RE: JMC Project 20101  
The Summit Club at Armonk Residential  
Bedford Road (Route 22)  
Town of North Castle, NY

**Response to Town Comments Resubmission**

**Town of North Castle Planning Department, dated January 18, 2022**

DRAWING NO.  
**A-101.A**

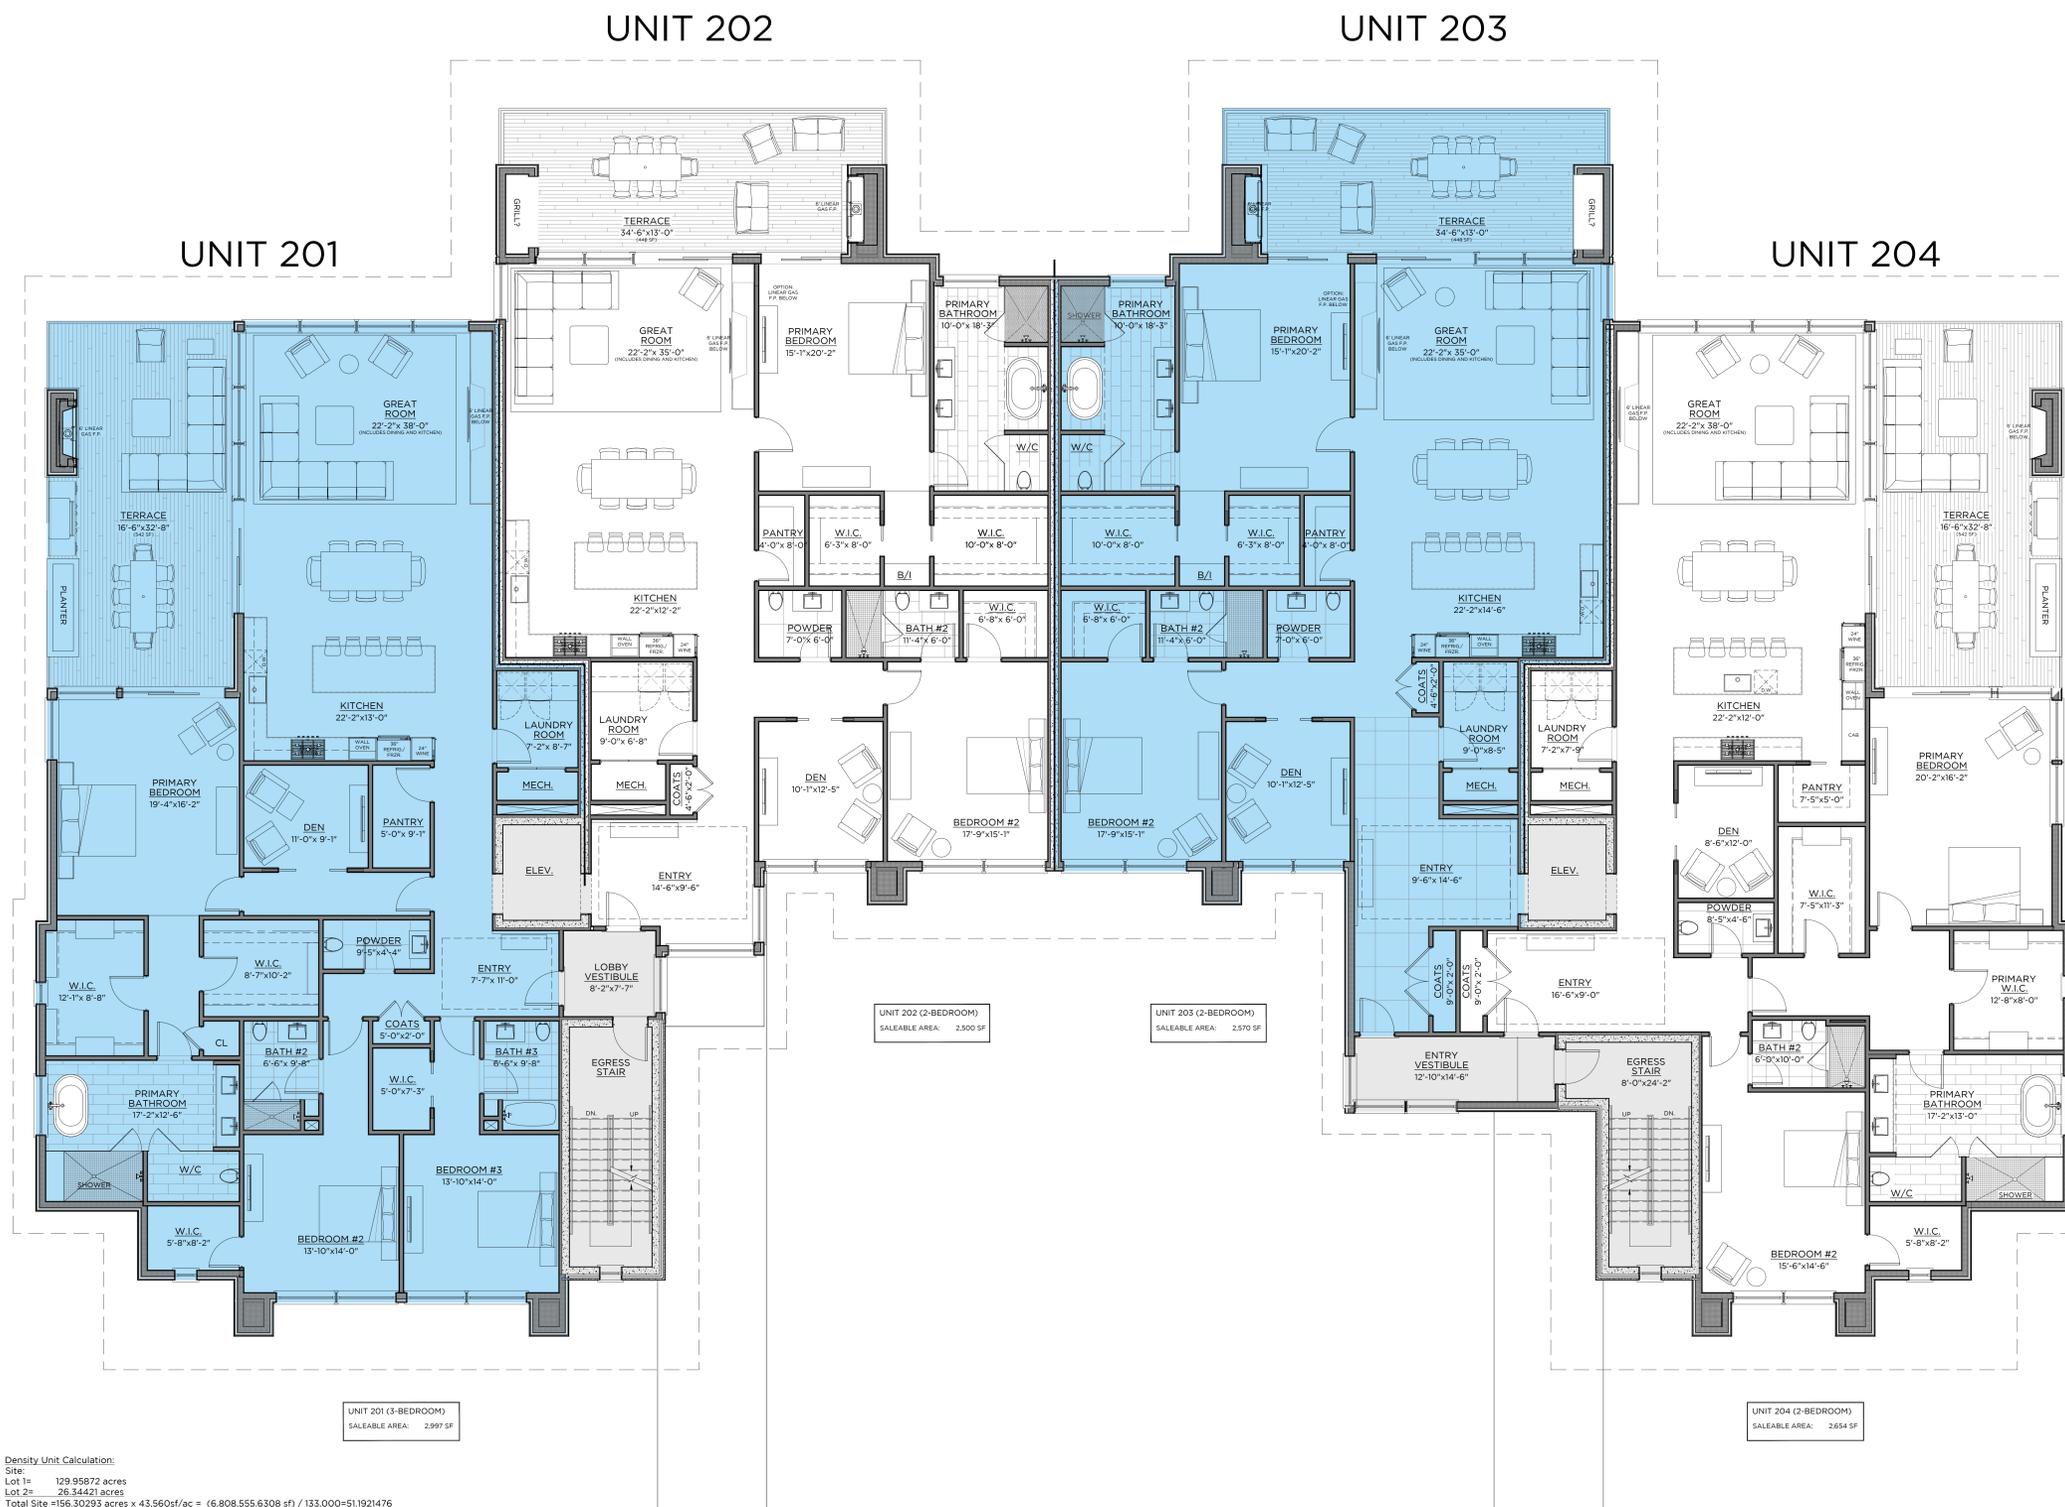
*The Chart on A101 is not correct and should be double checked. For instance, Building 3 and 4 are identified as having 9 units, but consist of 8 units (2 three-bedroom, 9 two-bedroom and 1 four-bedroom units). The number of units is important as the unit breakdown is needed to calculate density, off-street parking and AFFH requirements.*

The chart has been revised. See plan residential sheets.
